SUB-COMMITTEE ON SHIP DESIGN AND
CONSTRUCTION
7th session
Agenda item 3

SDC 7/3/2
28 November 2019
Original: ENGLISH
Pre-session public release:

**AMENDMENTS TO THE EXPLANATORY NOTES TO SOLAS CHAPTER II-1
SUBDIVISION AND DAMAGE STABILITY REGULATIONS (RESOLUTION MSC.429(98))**

**Proposal to determine the phrase "separation is of the same order" in the Revised
Explanatory Notes regarding SOLAS regulations II-1/7 and II-1/7-1.1**

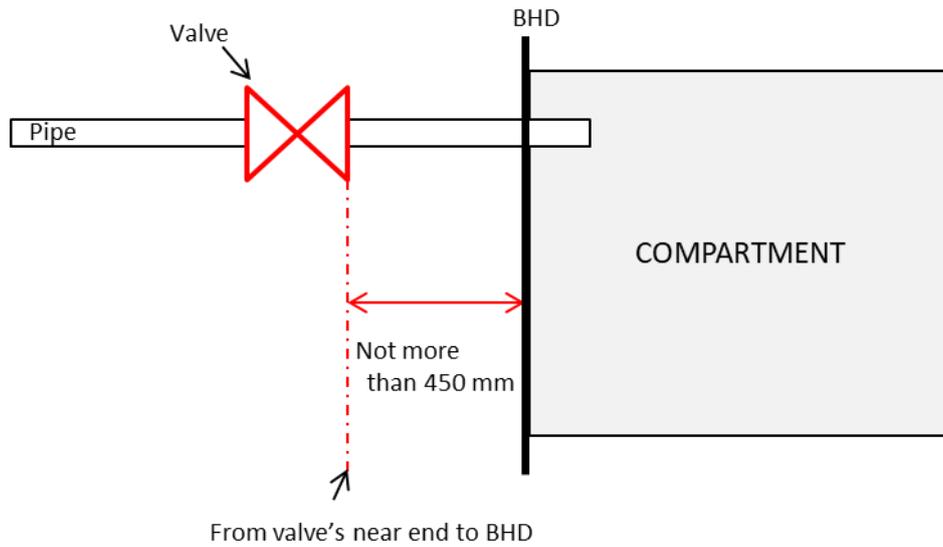
6 Having considered this issue, IACS has identified inconsistencies in the application of the Revised Explanatory Notes; some flag States require the whole body of the valve to be protected by the adjacent stiffeners, while others consider the practicality of the issue taking into account the size of the valve.

7 IACS considers that the Revised Explanatory Notes regarding SOLAS regulations II-1/7.7, 7-1.1.1 and 7-1.1.2 would benefit from further technical consideration of the phrase "separation distance of the same order as the bulkhead or deck stiffening structure". In this context, IACS considers the distance of 450 mm to prevent heat transmission in relation to penetrations in fire-resisting divisions, as prescribed in SOLAS regulation II-2/9.3.3.1, could provide the basis for a solution.

"... provided the separation distance ... is not more than 450mm measured from the valve's near end to the bulkhead or deck ~~of the same order as the bulkhead or deck stiffening structure...~~"

9 An example of the proposed arrangement is offered below for illustrative purposes.
